ADDENDUM

ADDENDUM NO.: 04
PROJECT NAME: Salt Dome Replacement Facility (Grand Avenue)
PROJECT NO.: 04021
CONTRACT NO.: C1598
DATE OF ISSUE: January 27, 2021

NOTICE OF CHANGES, MODIFICATIONS, OR CLARIFICATIONS TO CONTRACT DOCUMENTS

Sheet
S1.1

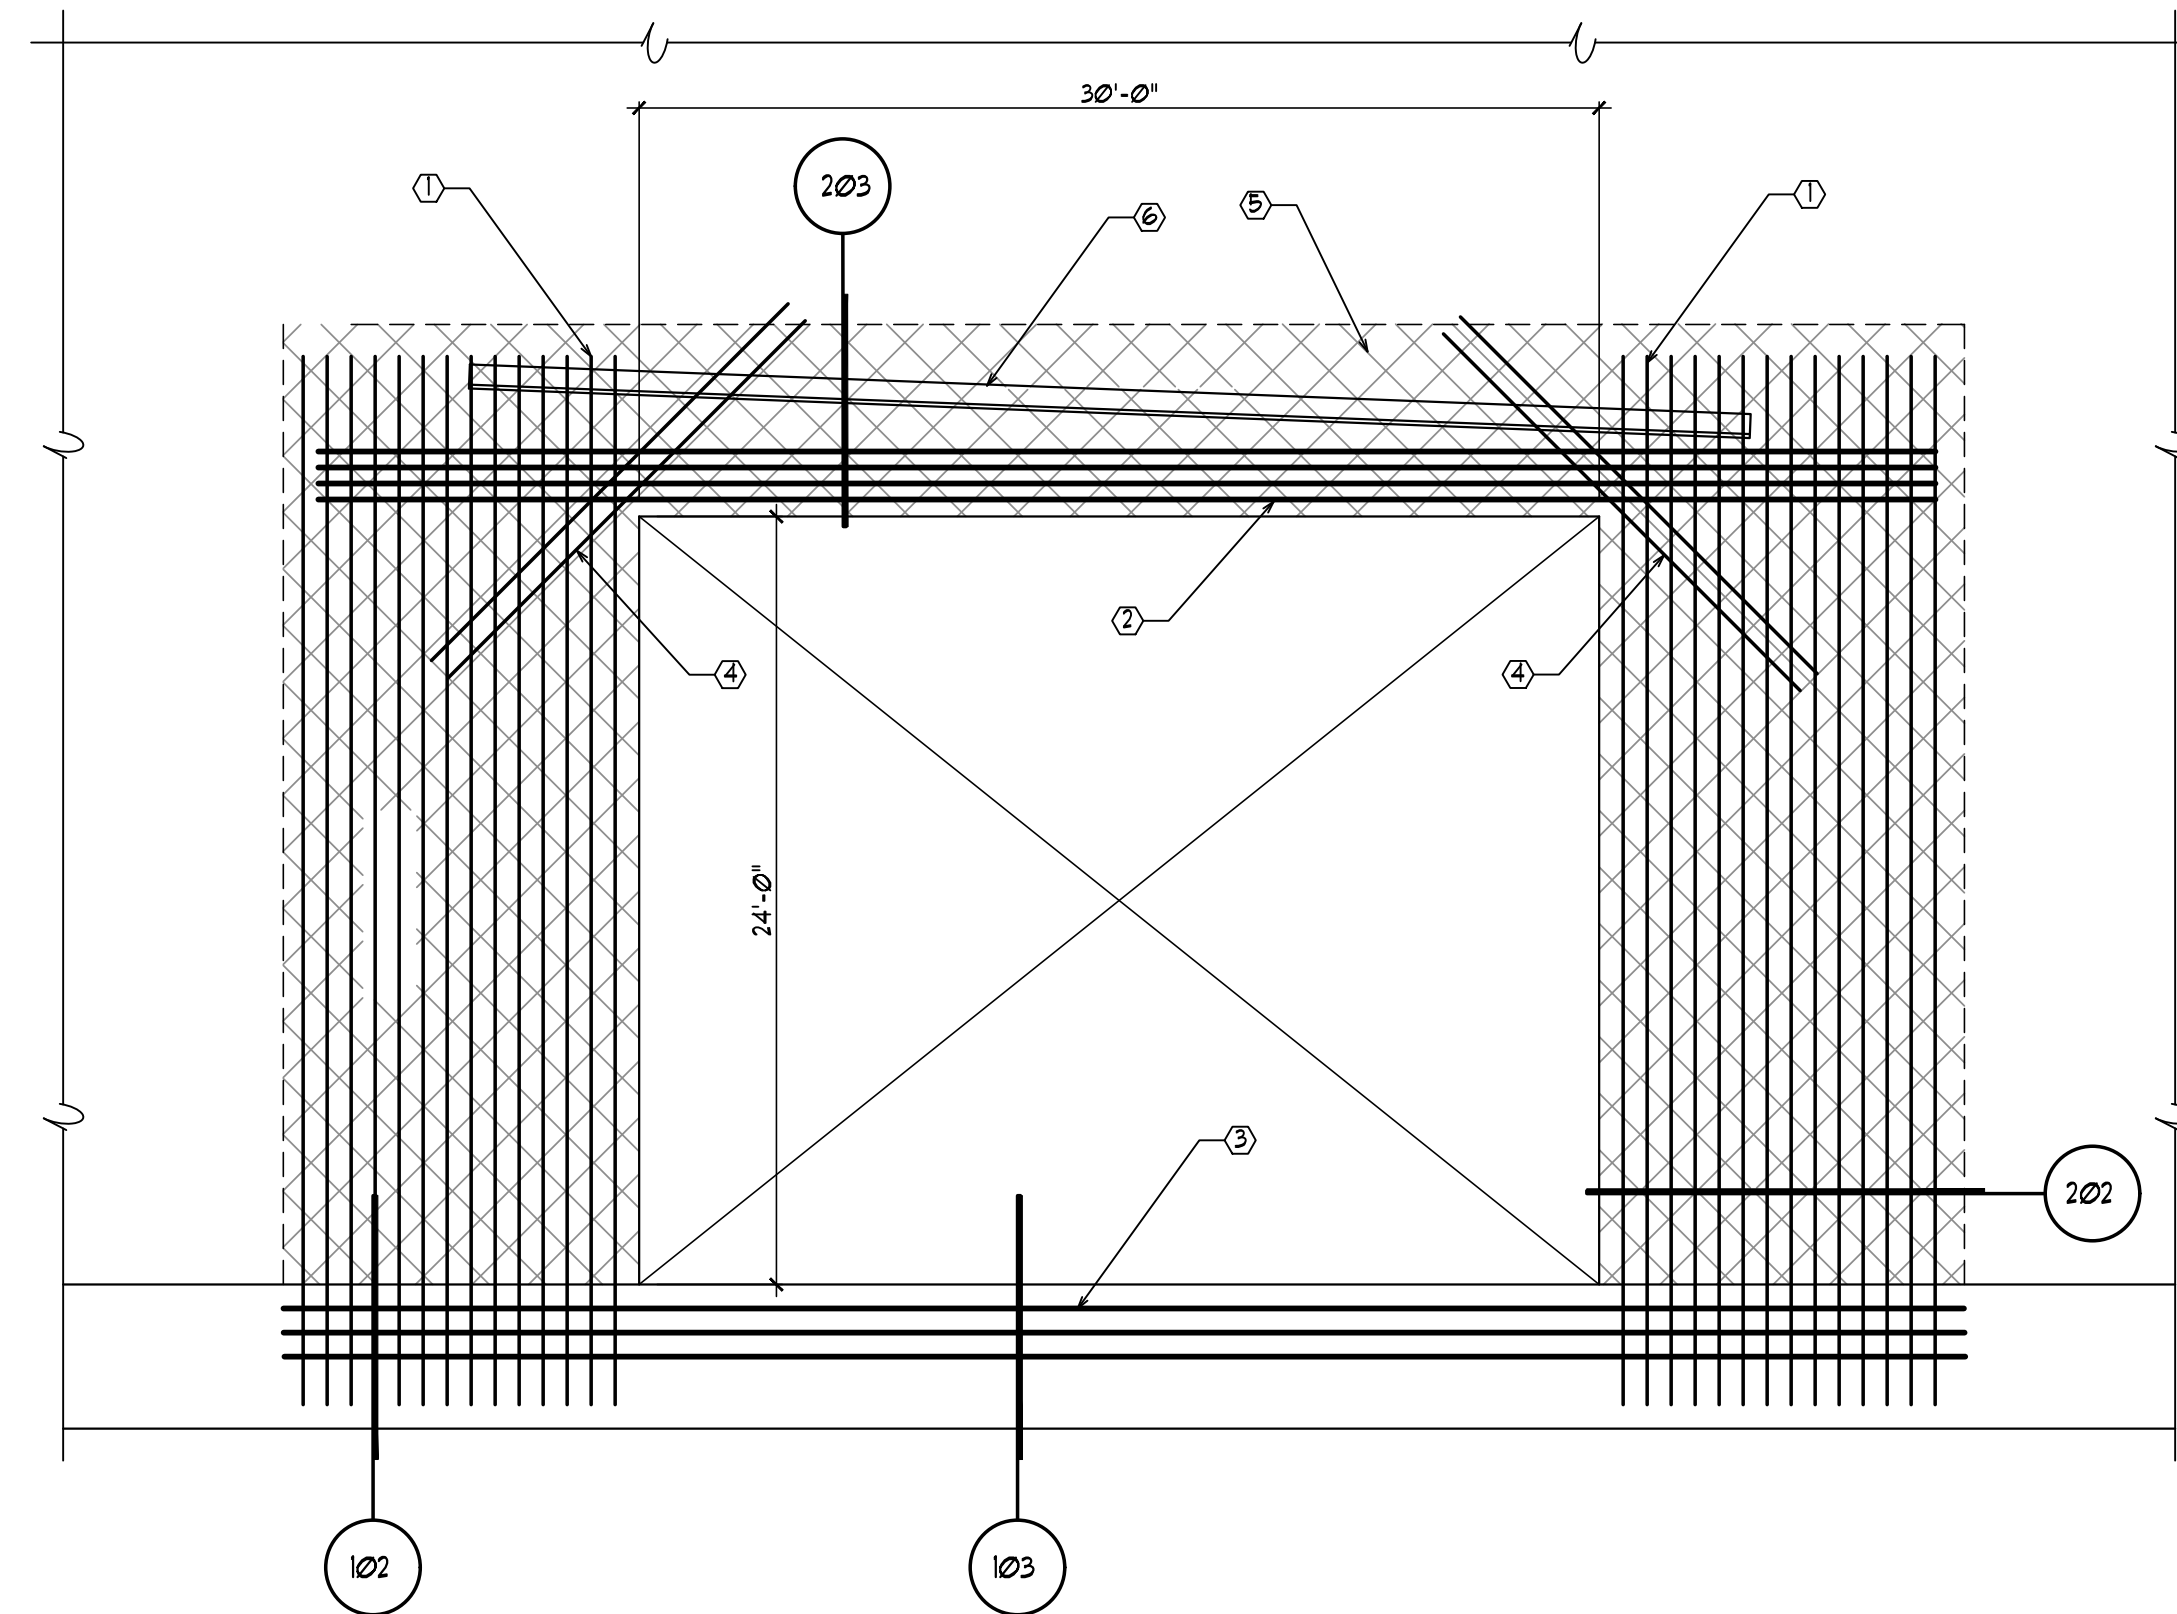
Change 6 **REVISED** Drawing No. S1.1, Foundation Plan: Note B revised to update floor slab subbase design.

B. CONCRETE SLAB SHALL BE 6" THICK OVER 3/4" PROPERLY COMPACTED DOT TYPE SUB BASE OVER PROPERLY COMPACTED SOIL. REINFORCE SLAB WITH #4 BARS AT 2' o.c. EACH WAY CENTERED IN SLAB THICKNESS. MOISTEN BUT DO NOT SATURATE SOIL IMMEDIATELY BENEATH SLAB PRIOR TO CONCRETE PLACEMENT.

104 TYPICAL ANCHOR BOLT CONFIGURATION
104-510190 NO SCALE

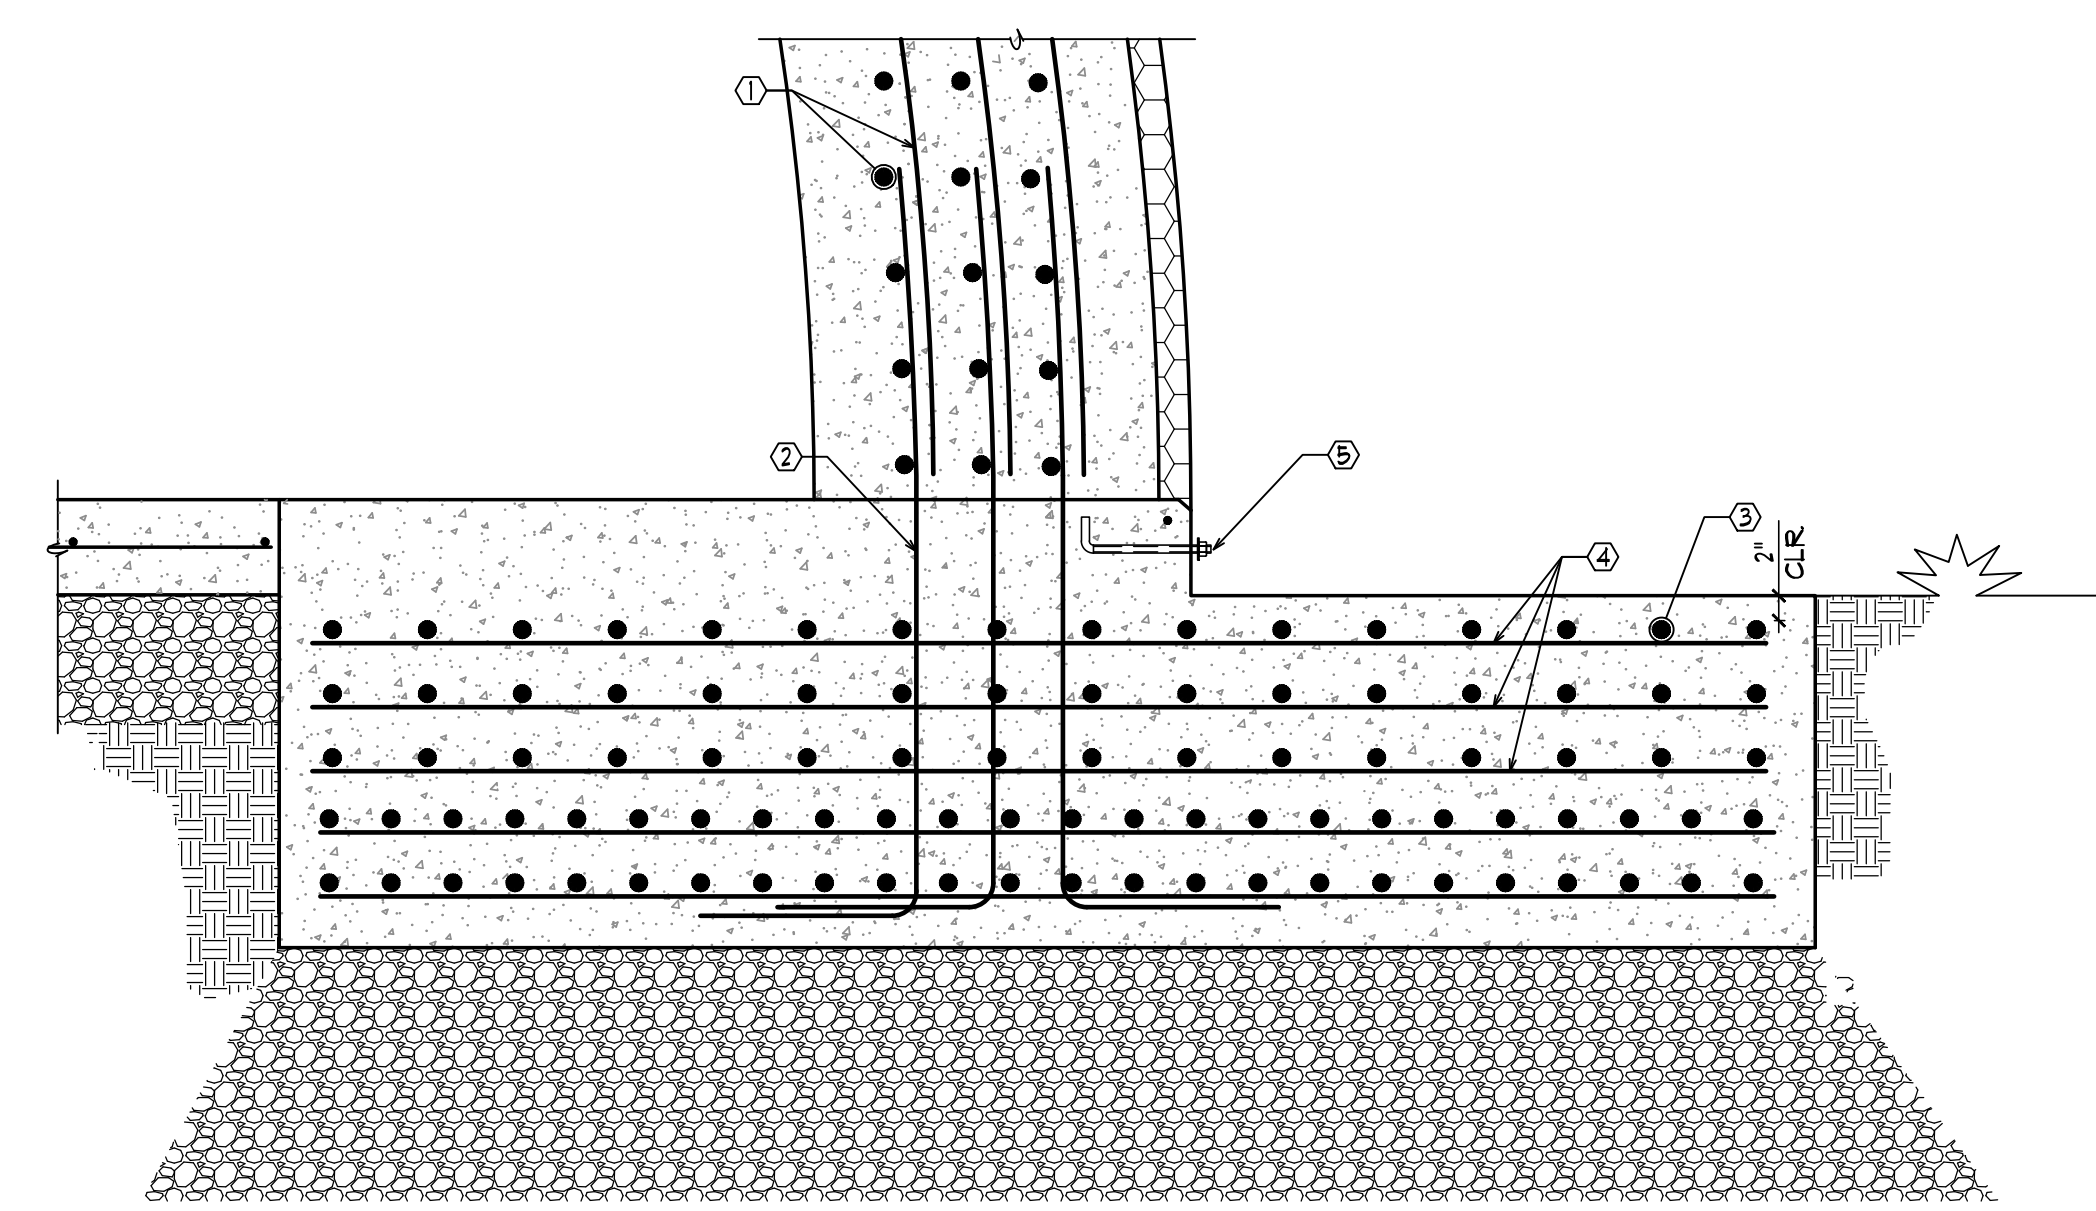
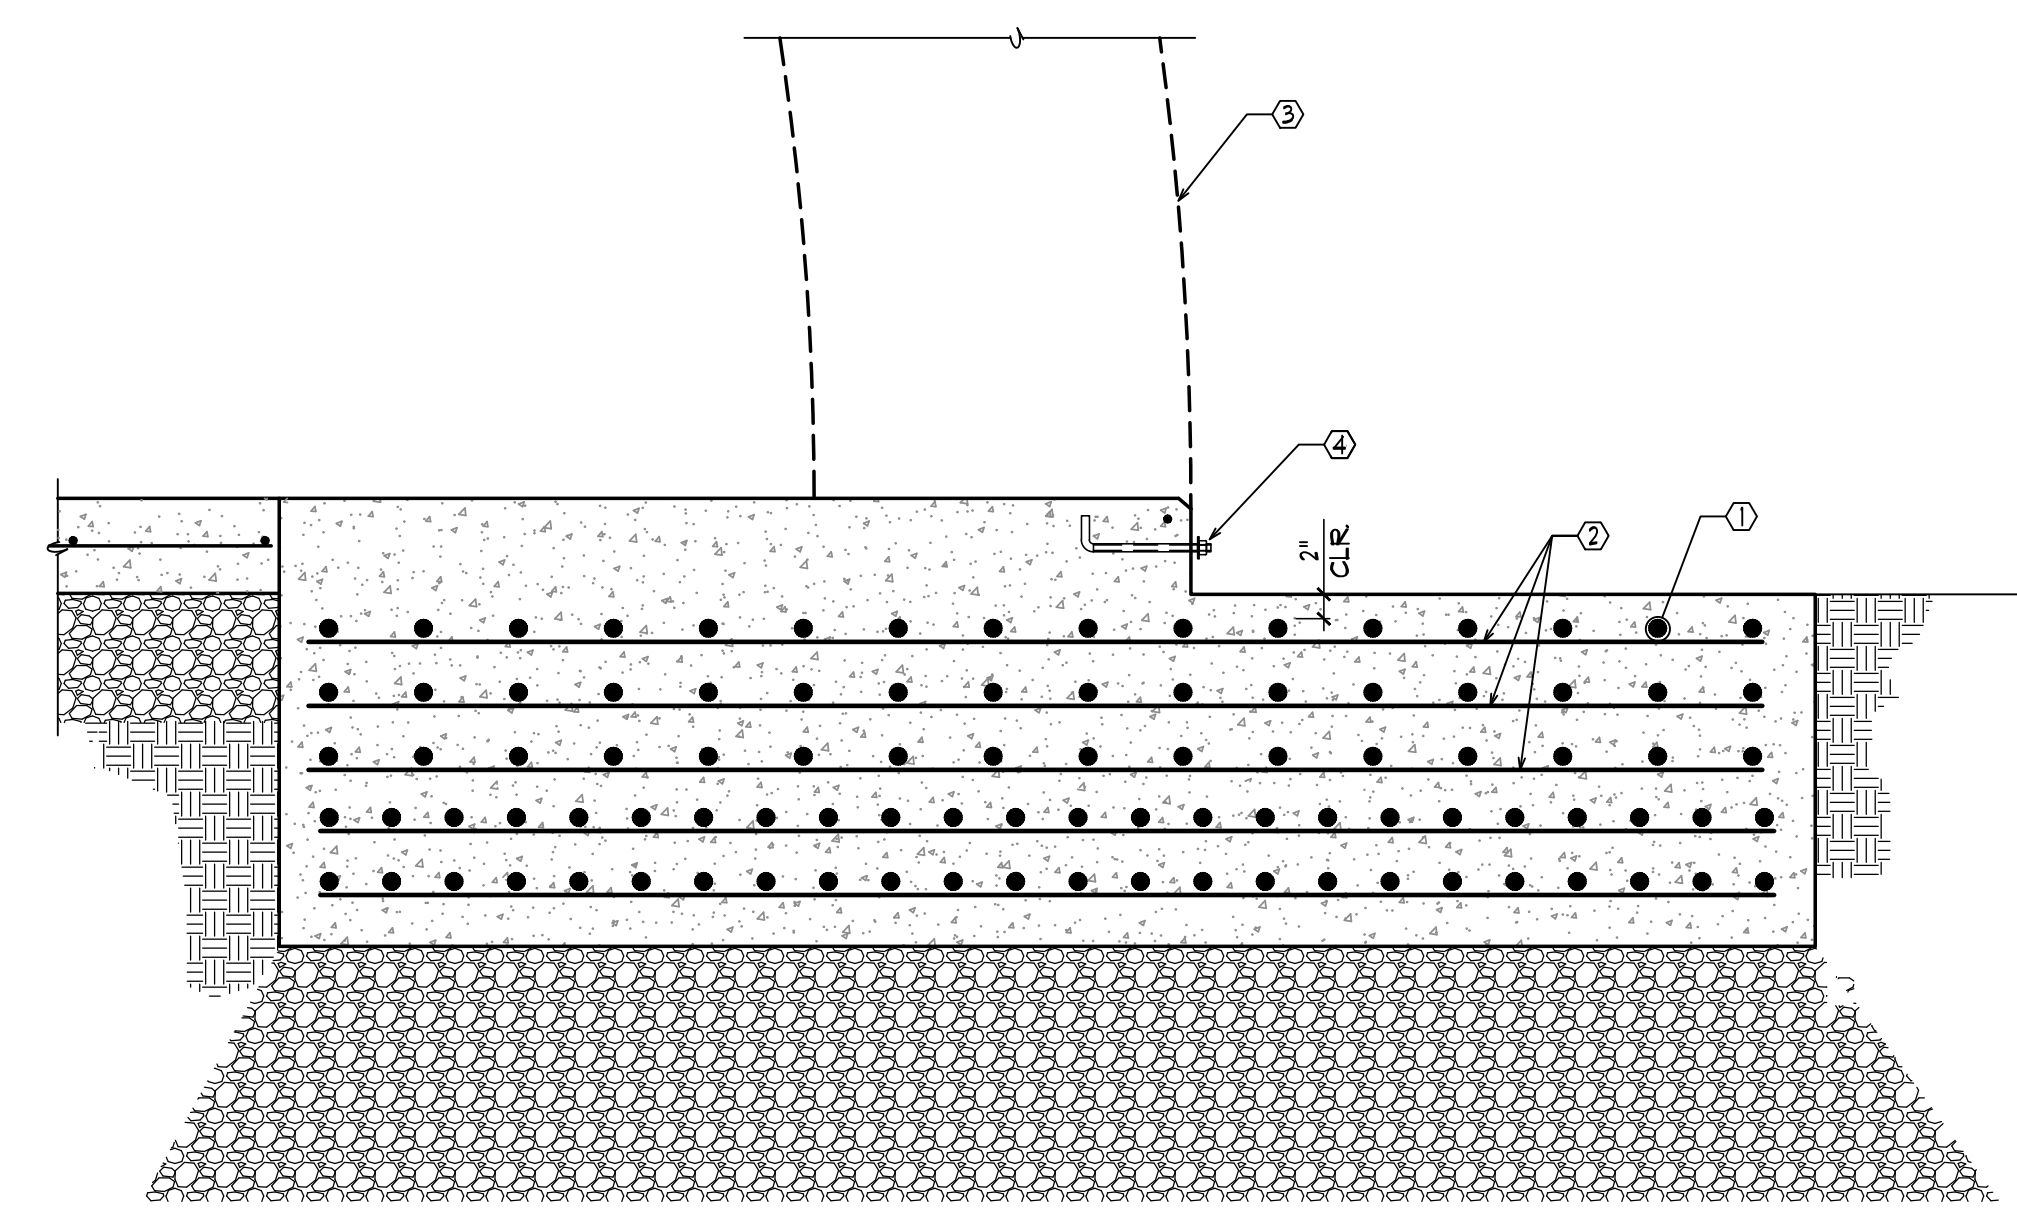
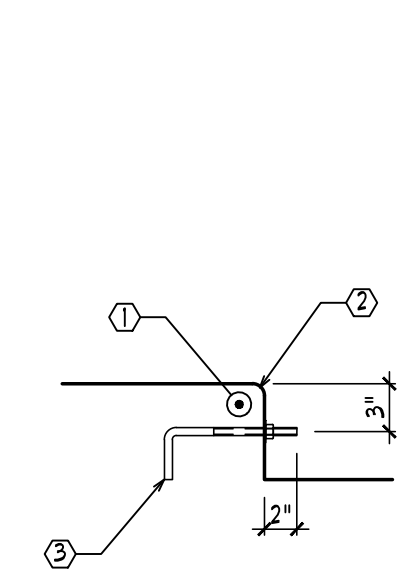
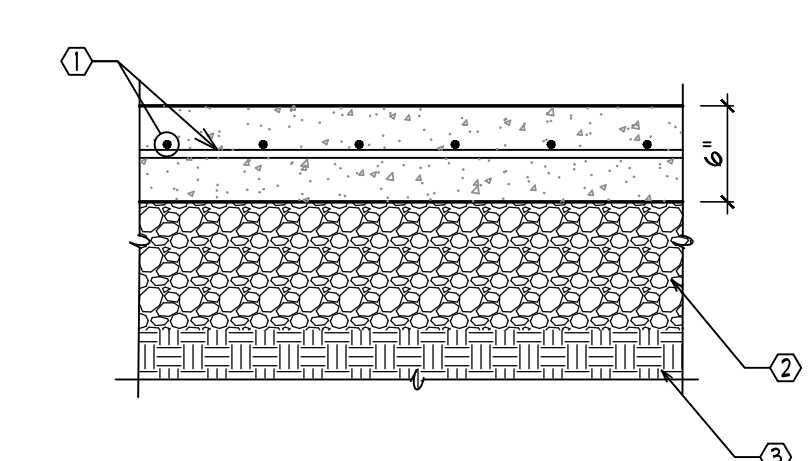
Change 7 **REVISED** Drawing No. S3.1, Details: Detail 105 revised to update floor slab subbase design. Details 101, 102, and 103 revised to properly identify anchor bolt details.

Question: Foundation details 101, 102 & 103 on sheet S3.1 show an anchor bolt located on the exterior side of the foundation. Please provide information on type, size and spacing of the anchor bolt shown..

Response: Drawing Sheet S3.1 has been revised and included in this Addendum to identify the anchor bolt type, size, and spacing are shown in detail 104.
